JINDAL ALUMINIUM LTD.
BANGALORE-560073 (INDIA)

NAME	DATE
DRAWN	PARVESH	21-10-2013
CHECKED		
APPROVED	S.S.GARG	21-10-2013
SCALE		0.5:1
AREA mm ²		1798.863
PERIMETER mm.		527.313
WEIGHT kg/m		4.857
DRAWING No.		SECTION No.
P-12513		-
10446		10446(ISSUE-3)

PARTY'S NAME	BANGALORE MARKET (ROLLING MILL DIVISION)
PARTY'S DRAWING No.	AS PER SPECIFICATION
ALLOY & TEMPER	19700
DESCRIPTION	FLAT BAR

10446

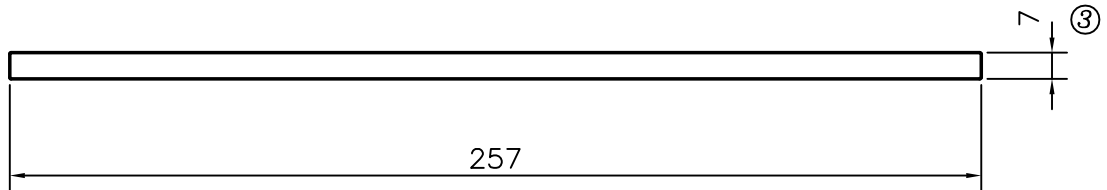
ISSUE (2) :-

☞ TOLERANCE ADDED ON THICKNESS.

ISSUE (3) :-

☞ THICKNESS CHANGED FROM 5.5 TO 7.0 mm.

☞ WEIGHT ALSO CHANGED FROM 3.816 Kg/M. TO 4.857 Kg/M.
